CMP Review

Project: 13 Belsize Crescent, London, NW3 5QY

Ref: 15172

Version: V1.2

Fig. 4.

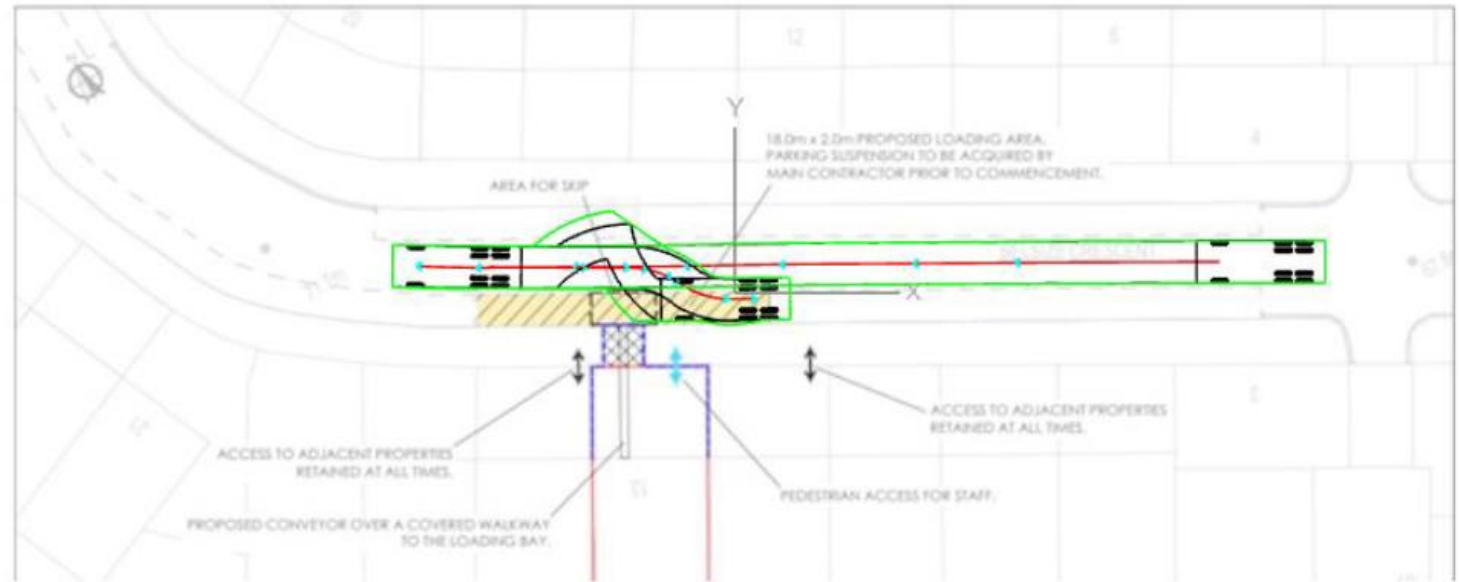
Figs 4 & 5 demonstrate the infeasibility of an 18t tipper vehicle, the largest anticipated vehicle according to the existing CMP, accessing the proposed loading area. The loading bays are stated as 2m in width, which is 55cm less than the width of such vehicles.

Additionally, the proposed skip location renders the required manoeuvre impossible without either encroaching on the parking bays and/or pavements or striking the skip itself.

Further analysis has shown that any vehicle greater than 3.5 tonnes will struggle to make this manoeuvre.
